## **Historic Architectural Review Commission Staff Report for Item 11**

Application Number: C2026-0028

Address: 705 Chapman Lane

Demolition of side and rear historic additions.

1  
A-4 EXISTING FRONT ELEVATION WEST  
SCALE: 1/4" = 1'

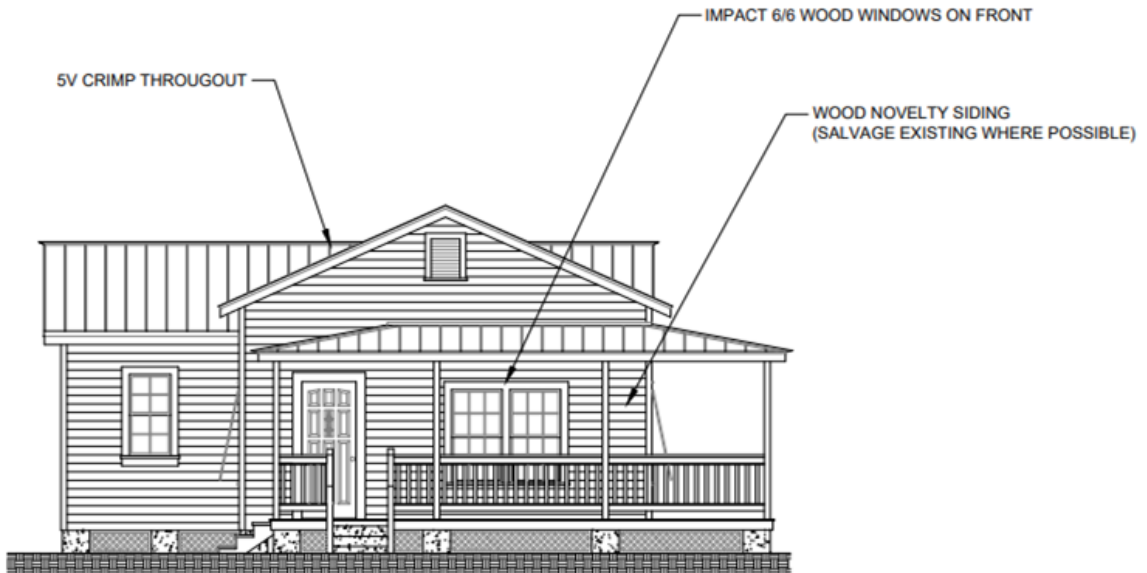
The proposed repairs and replacement windows on the main portion of the house help maintain the historic appearance of the structure. Wood windows on the front elevation and aluminum windows on the side elevations are appropriate. The proposed rear deck is located at the rear and remains subordinate to the main structure. Overall, staff finds the proposal maintains the historic character of the property and surrounding area.

3 EXISTING REAR ELEVATION EAST  
 A-4 SCALE: 1/4" = 1'

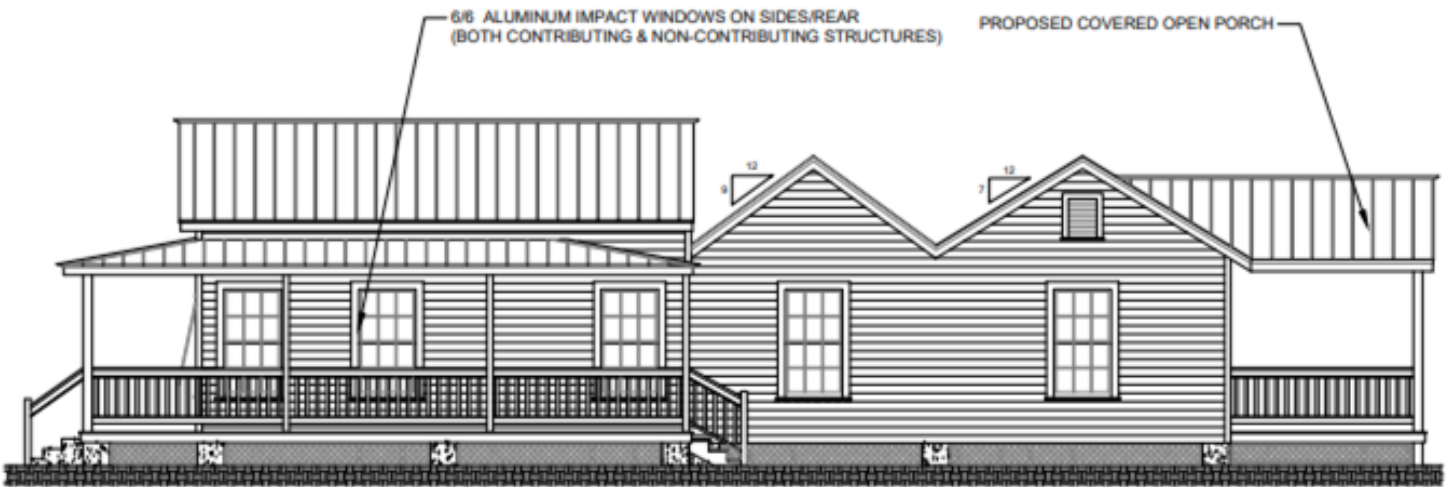
A Certificate of Appropriateness is currently under review for two new one-story sawtooth additions and a new covered deck at the rear of the property. The proposed sawtooth additions are designed to closely match the existing historic sawtooth structures and will feature Hardie novelty siding, 5V-crimp metal roofing, 6 over 6 aluminum windows, and French doors at the rear elevation. The new covered rear deck will be wood leading to the rear yard. Proposed renovations to the main house include the removal of one window on the south elevation, removal of existing Bahama shutters, repairs to the existing wood novelty siding, installation of new 6 over 6 wood windows on the front elevation, and aluminum windows on the side elevations. There will be wood lattice in between piers. The proposed demolition includes the removal of the existing rear historic one-story sawtooth structures.

2  
A-5 PROPOSED SIDE ELEVATION SOUTH  
SCALE: 1/4" = 1'

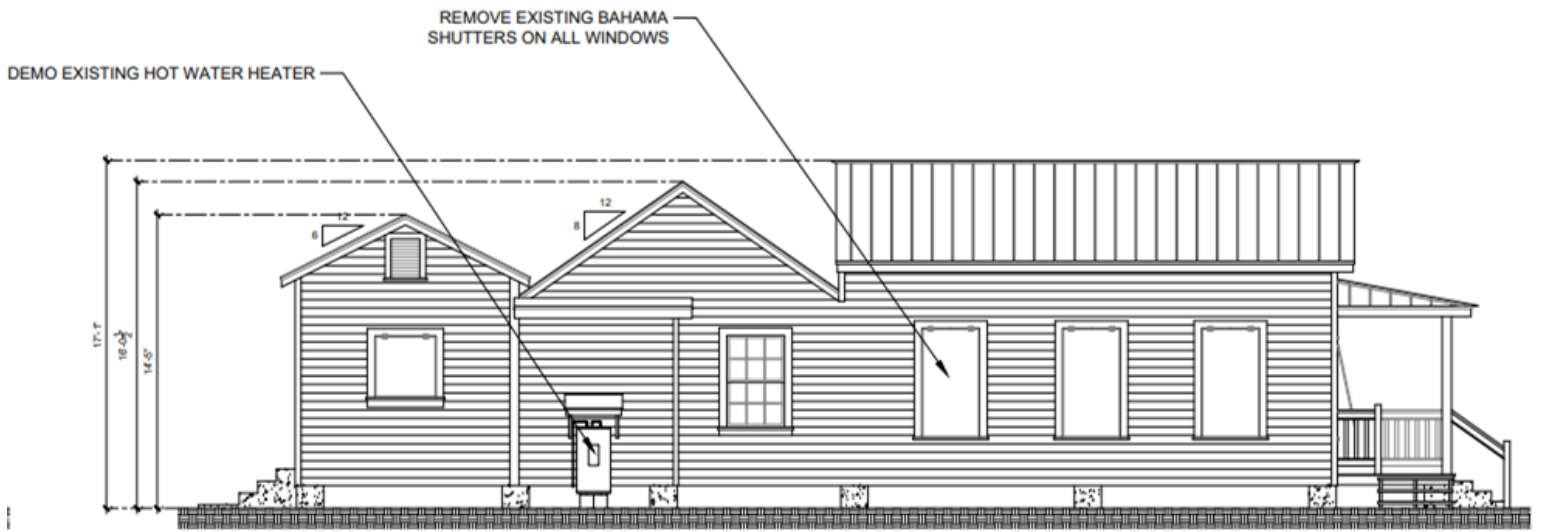
Staff finds the proposed additions and renovations to be generally consistent with the HARC Guidelines. The new one-story sawtooth additions are designed to closely resemble the existing historic sawtooth structures in scale, form, and appearance. The proposed materials, including Hardie novelty siding, 5V-crimp metal roofing, and 6 over 6 windows, are compatible with the historic character of the property and surrounding neighborhood.
